60 Dutton Street, Coolangatta

Information Request Response including –
Appendix A - Copy of Council's Information Request

Response to Information Request

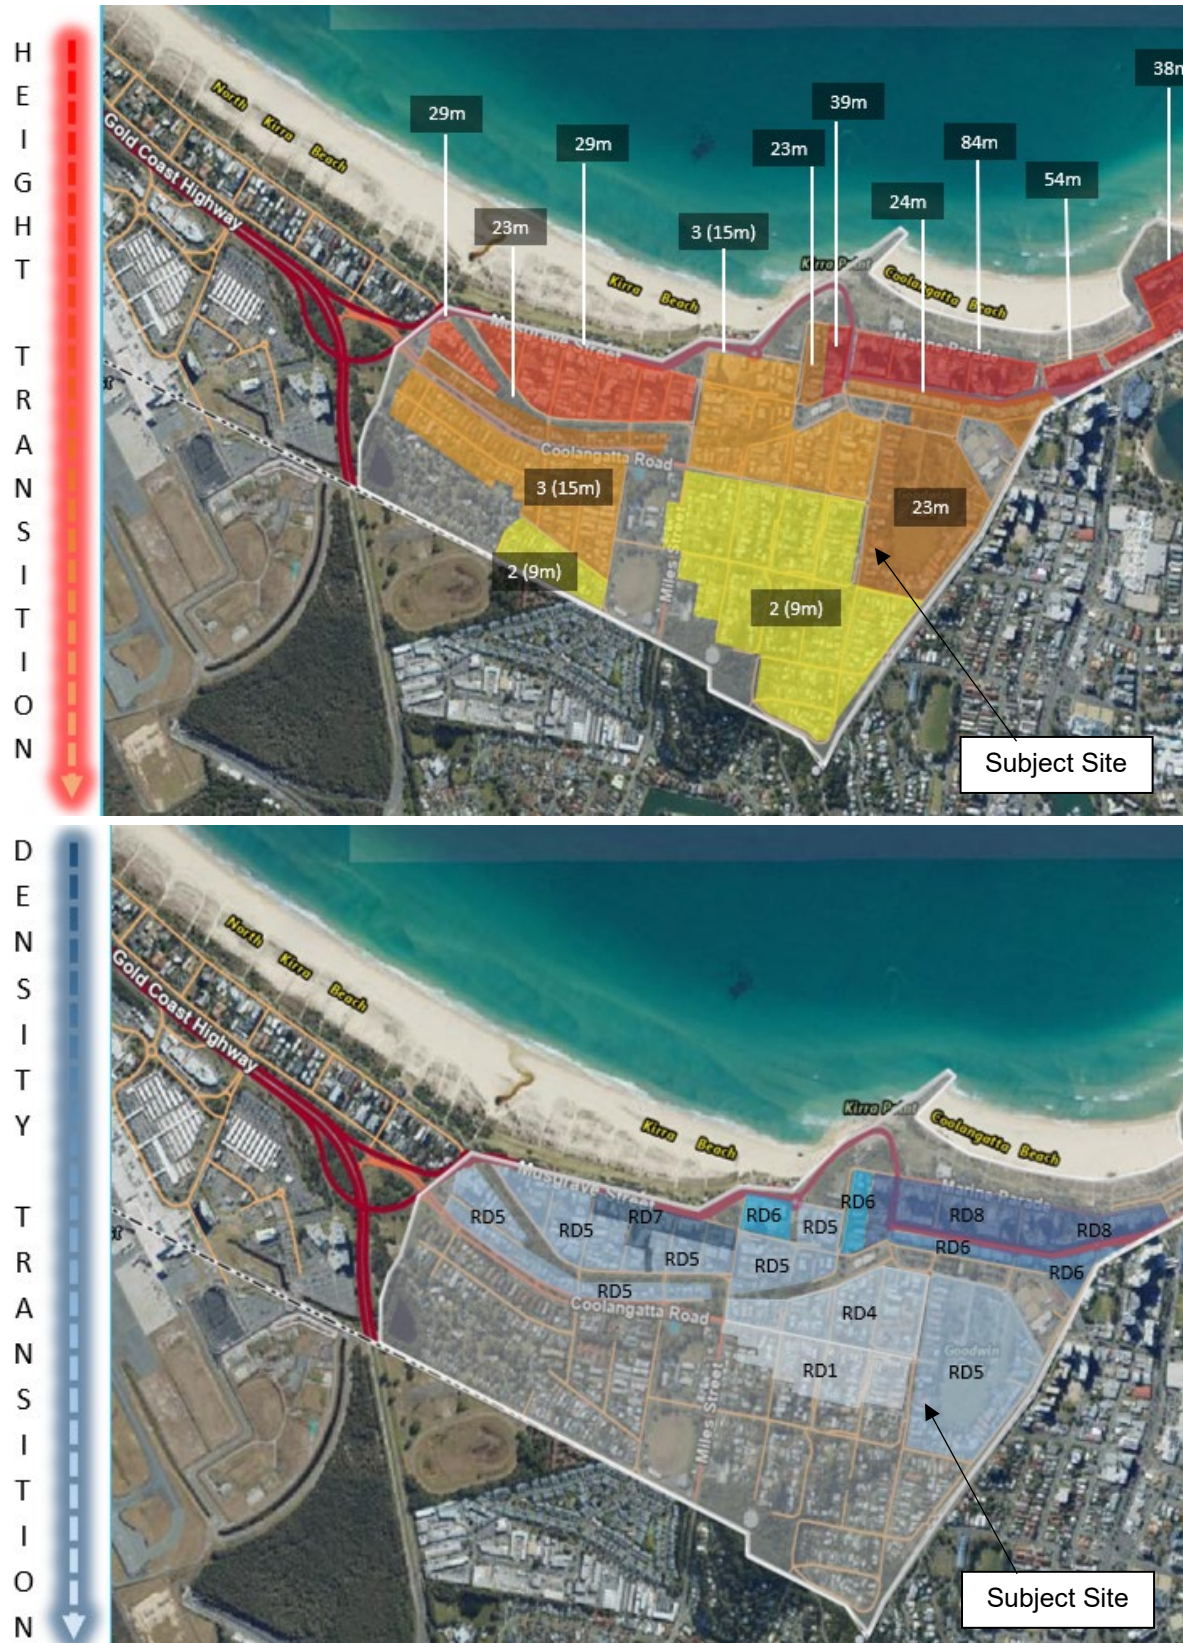
The Strategic Framework terms “local identity” and “sense of place” are broad concepts not defined within the City Plan. It is considered that the above concepts are not just experienced from a static viewpoint and are also experienced by moving through an area being cognisant of existing and envisaged built form outcomes as significant contributors to each. In order to enable an accurate assessment of the proposal against the Strategic framework - Urban neighbourhood Elements: Specific outcome 3.3.2.1 (9)(b), City officers request the following:

- a. The applicant is requested to define the local area used to determine local identity and sense of place.*
- b. Submit a character analysis of the local area that analyses the established and envisioned development, including any new developments constructed or approved above the mapped height designation, to demonstrate the proposal meets the above specific outcome.*

Note: Council officers are agreeable to liaising with the applicant regarding what constitutes the local area before undertaking the requested character analysis. If it cannot be demonstrated that the development effectively reinforces local identity and sense of place, reductions to building height may be required.

RESPONSE: Consideration of the ‘local area’ as relevant to the site and proposal, and with particular regard to the intention of the City Plan (and previous planning schemes) in terms of locational attributes, zoning, residential density, and building height provisions is reflected in the accompanying **Coolangatta Character Assessment** contained in **Section 4 – Specialist Reports**. An overview of assessment is provided below.

For the purposes of the character assessment, the local area is defined as the general Coolangatta region with a narrowing focus to the area broadly surrounding Goodwin Park. Consideration of the general Coolangatta area is necessary in order to demonstrate the deliberate intention of the City Plan

for a 'transition' from higher scale and intensity along the coastal spine / beachfront and Coolangatta centre to a reduced scale and intensity to the south comprising suburban zoning, and lower building heights and residential density.

In this regard the assessment found that the area in between the higher intensity coastal area and lower intensity suburban area to the south, is a transition area of which properties adjoining Goodwin Park including the subject site form a key part. These areas incorporate the Medium density residential zone, with mid-rise building heights, and medium density provisions, and capture an evolving urban character influenced by recent development trends in line with the City Plan provisions.

The submitted character assessment identifies a clear built form evolution in the local area, including several recently approved or constructed developments that exceed the mapped 23m height provisions as shown below –
